UNITED STATES PATENT AND TRADEMARK OFFICE

10/711,487

Office Action Summary	Application No. 10/711,487	Applicant(s) JOSHI ET AL.	
	Examiner Sunil Singh	Art Unit 3672

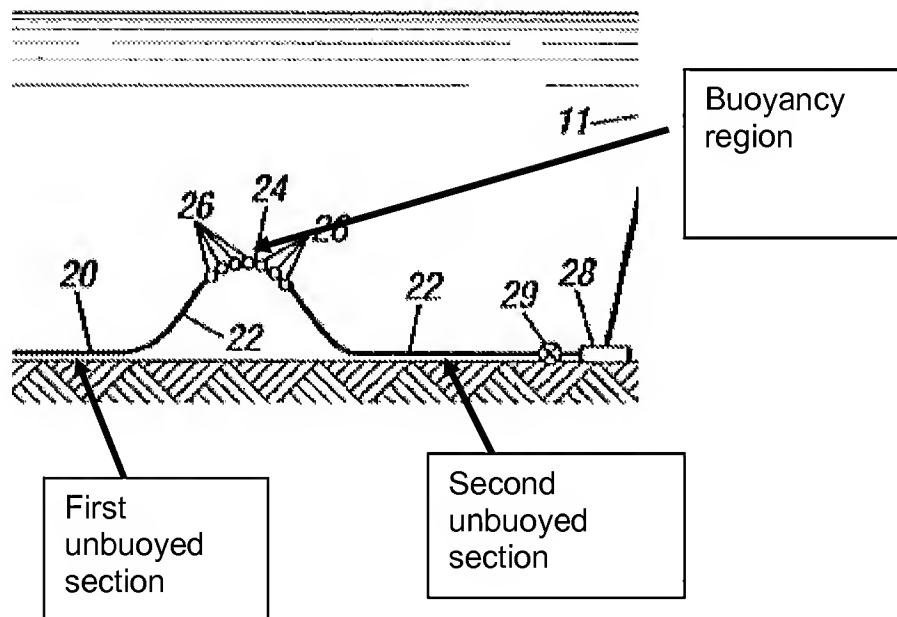
2. Claims 66-68,71,72 are rejected under 35 U.S.C. 102(b) as being anticipated by Richmond et al. (US 5582252)

Richmond et al. discloses a pipeline comprising a first unbuoyed section (see drawing below, Fig. 2), second unbuoyed section (see drawing below, Fig. 2), at least one buoyancy section (24,26) disposed between the first and second sections.

9. Applicant's arguments filed 8/1/08 have been fully considered but they are not persuasive. Applicant argues that Richmond et al. makes no mention of laying a pipeline across a topographic feature. The examiner disagrees. See Figure 2, topographic is defined as surface feature of a region, wherein the surface feature could be flat; therefore, Richmond et al. shows laying a pipeline across a topographic feature.
